MFN 06-262
Supplement 4

Subject: **Modified Reactor Building/Fuel Building Truncated Model,
SER-ESB-038 Rev. 5**

**Shimizu Engineering Report SER-ESB-038, Rev. 5,
“Modified RBFB Truncated FE Model Analysis Data,”**

Project	General Electric Company ESBWR Project	Shimizu Document No.	SER-ESB-038
Title	Modified RBFB Truncated FE Model Analysis Data	Rev.	5
		Issued Date	9/22/06
		Revised Date	1/9/07

Figure C-39 Element Forces Comparison NASTRAN to ANSYS (Basemat Section C-C: Out-of-plane Shear [MN/m])

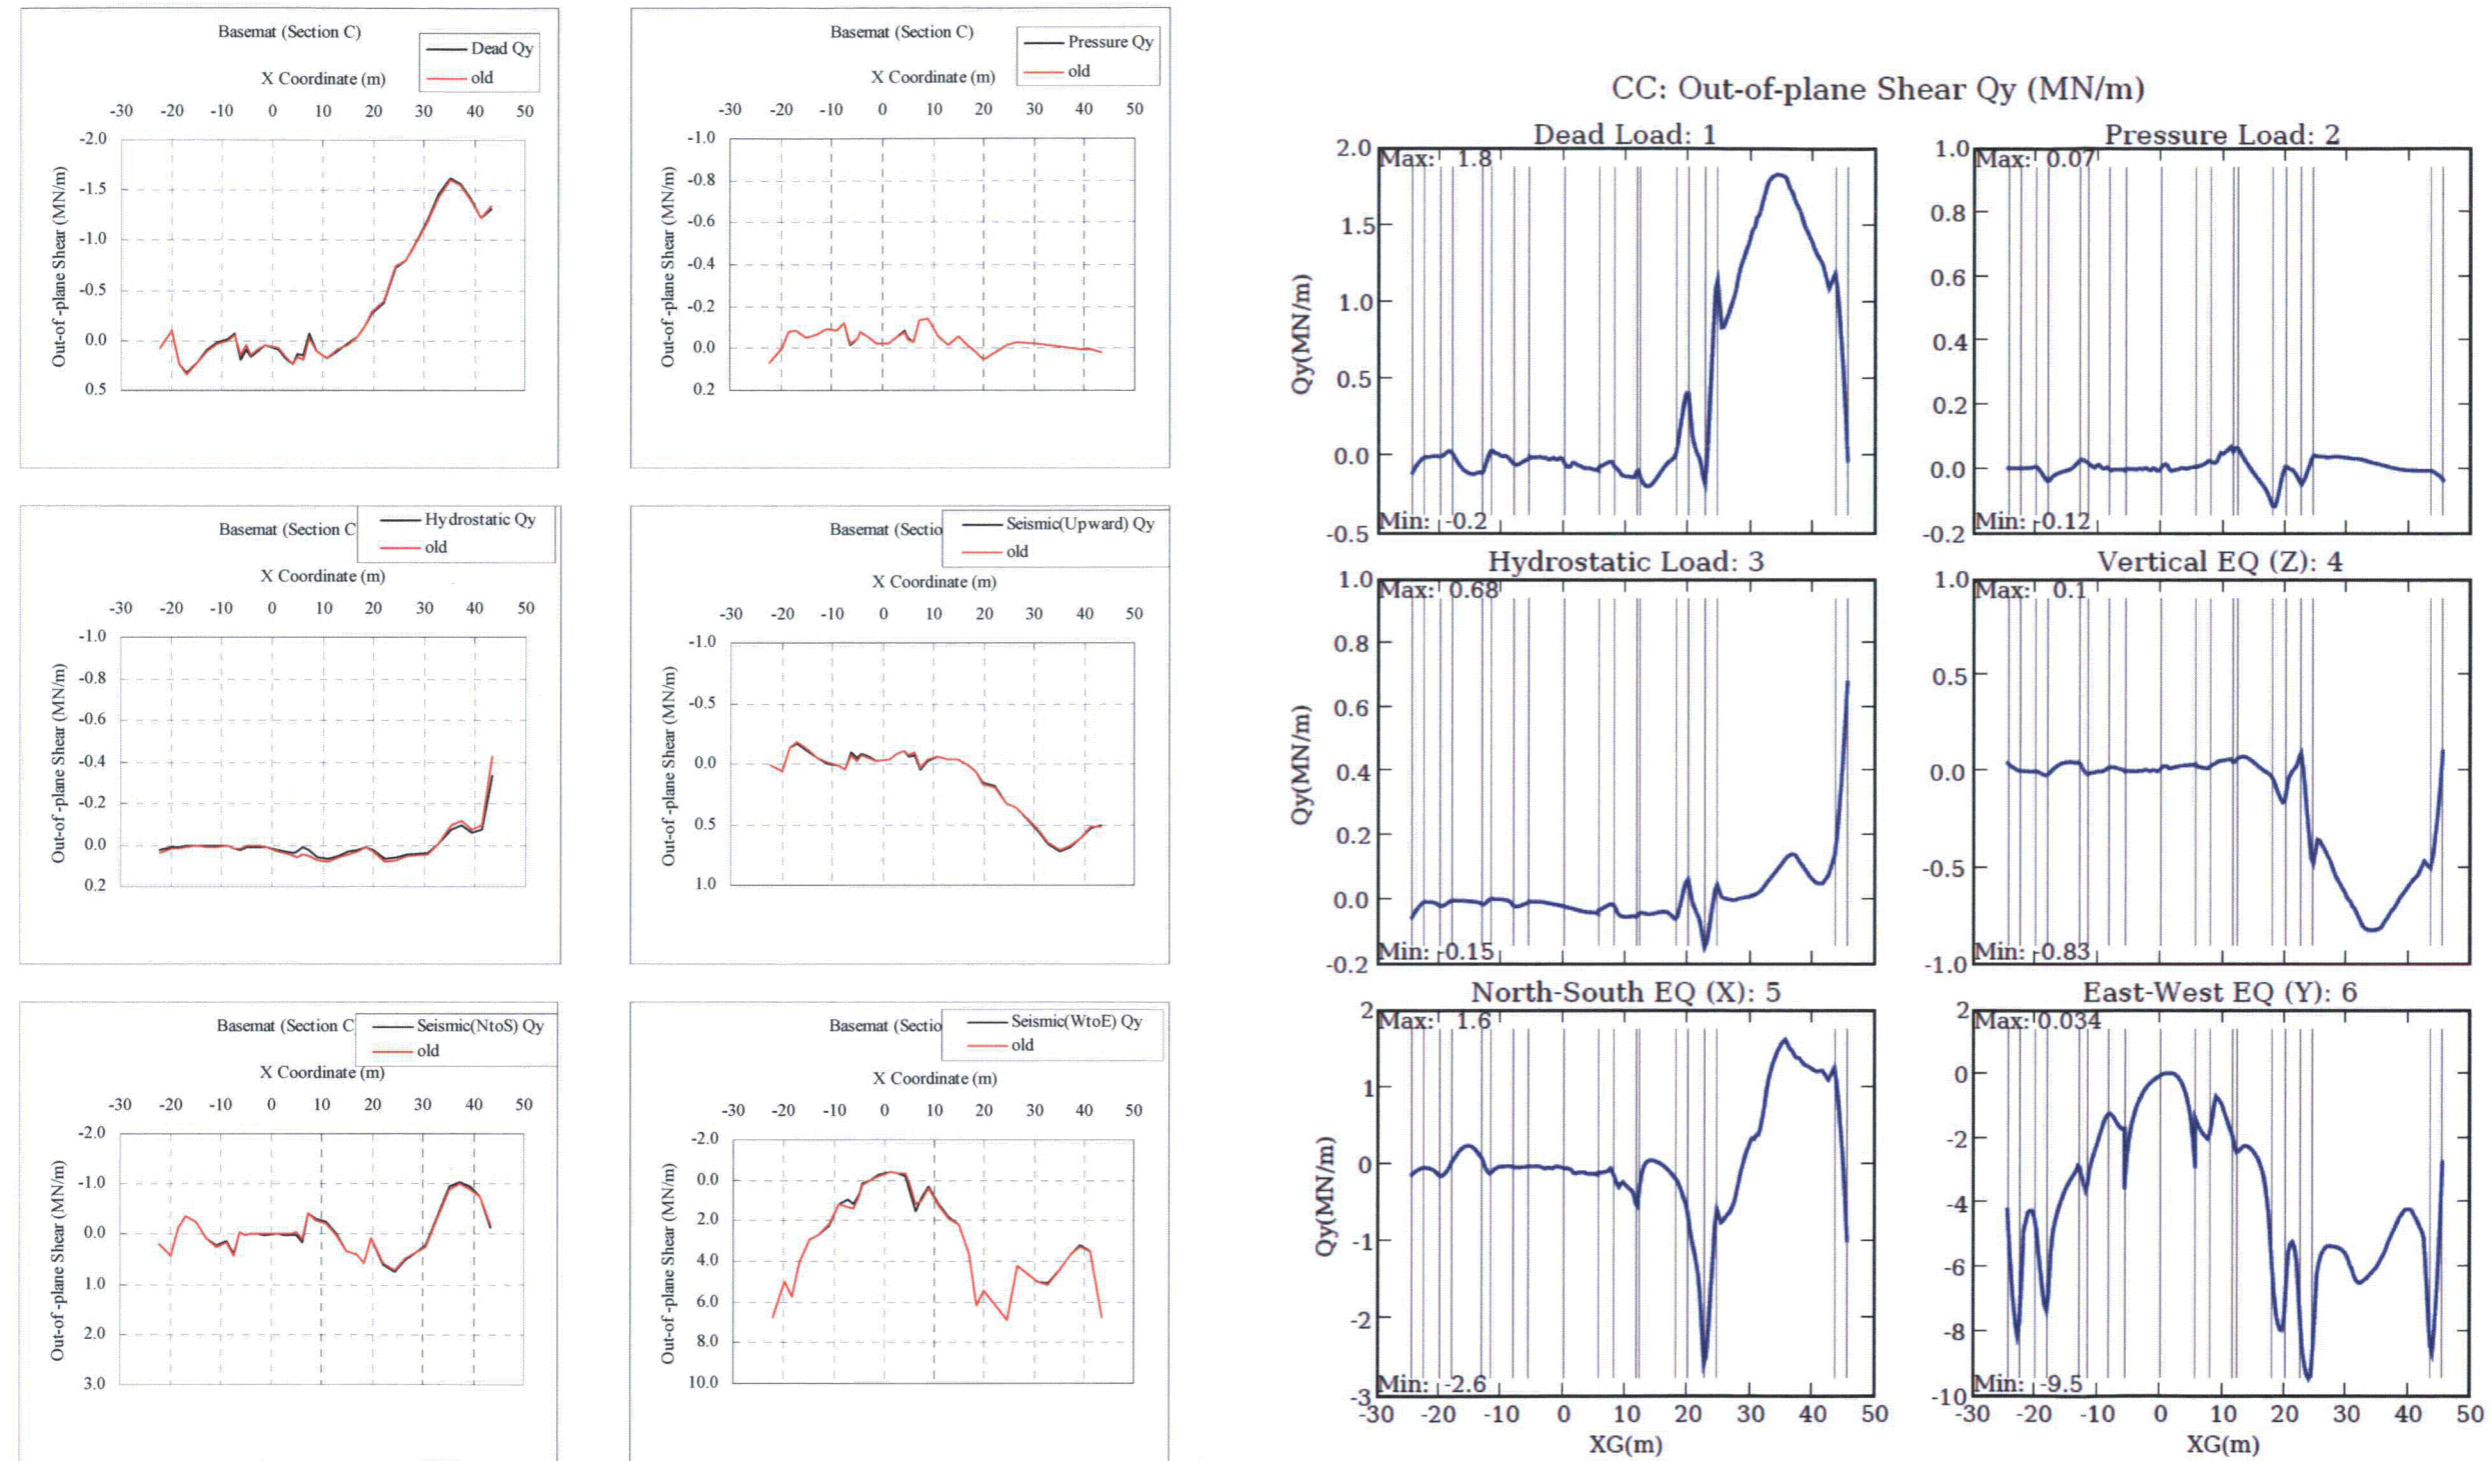
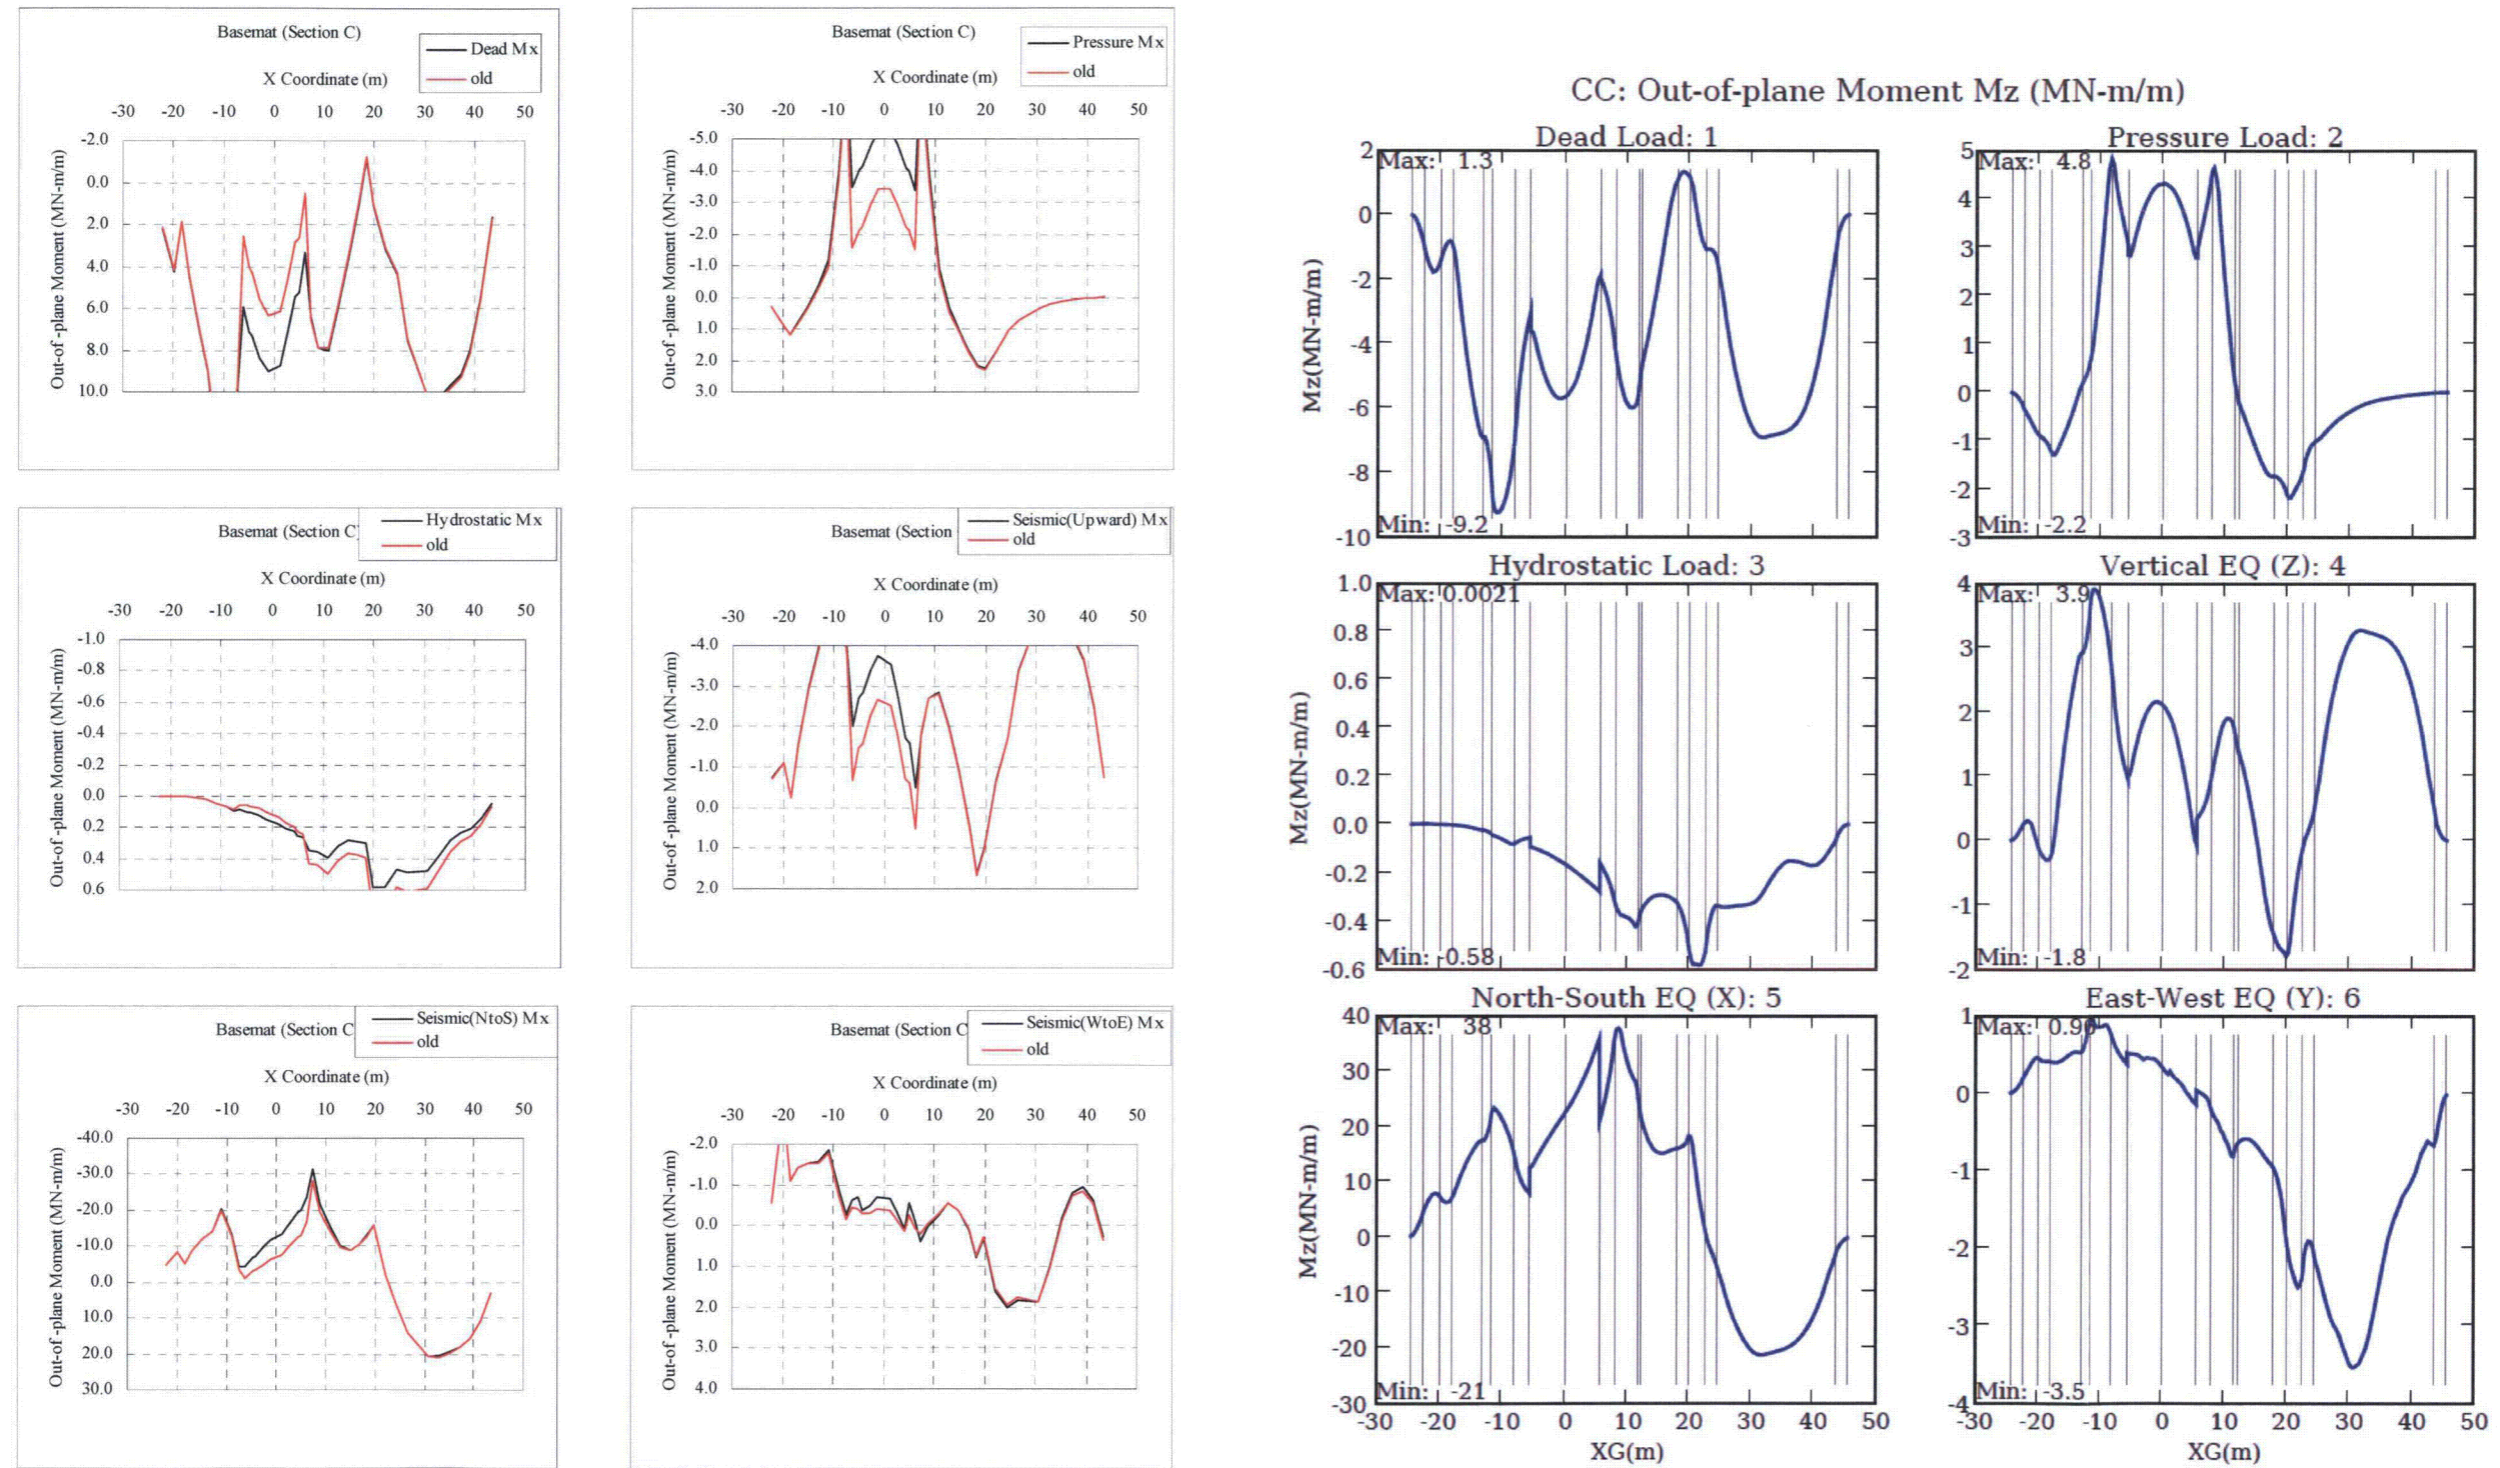
- iii) *The differences of magnitude of forces appeared on basemat inside pedestal:* The result of re-analysis using the updated model shows better agreement. In case of seismic load the magnitude of forces has to be re-compared because BNL's soil spring may not be adequate as pointed out above 3).

- iv) *The differences of magnitude of forces appeared on outer wall of Fuel Storage Pool (FSP):* For the out-of-plane shear forces and moments on RA and F3 wall located around FSP in case of Hydrostatic load, BNL's results are lower than those of GE. GE assumes the some part of differences comes from the difference of estimation levels between both models as pointed out above 8). In order to have a better understanding of the differences, GE would like to request BNL to confirm the input data for Hydrostatic load.
